La Marzocco Technical Bulletin #141

Updated Swift Grinder Electronic Board December 26, 2017

5.305.1 TRANSFORMER BOARD SWIFT VER3

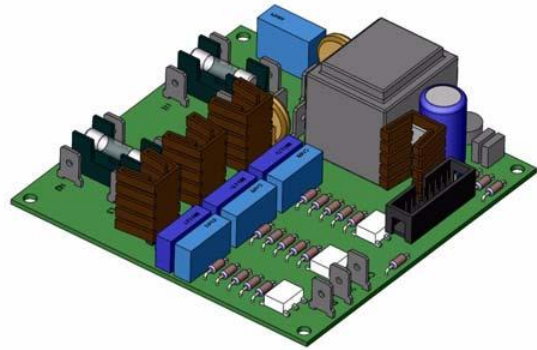
The Swift transformer board has been updated with new triacs. The new triacs can handle more cycles increasing the lifespan of the board. The part number has not changed and is as follows:

The updated Swift transformer board is backwards compatible with existing, current generation, button pads.
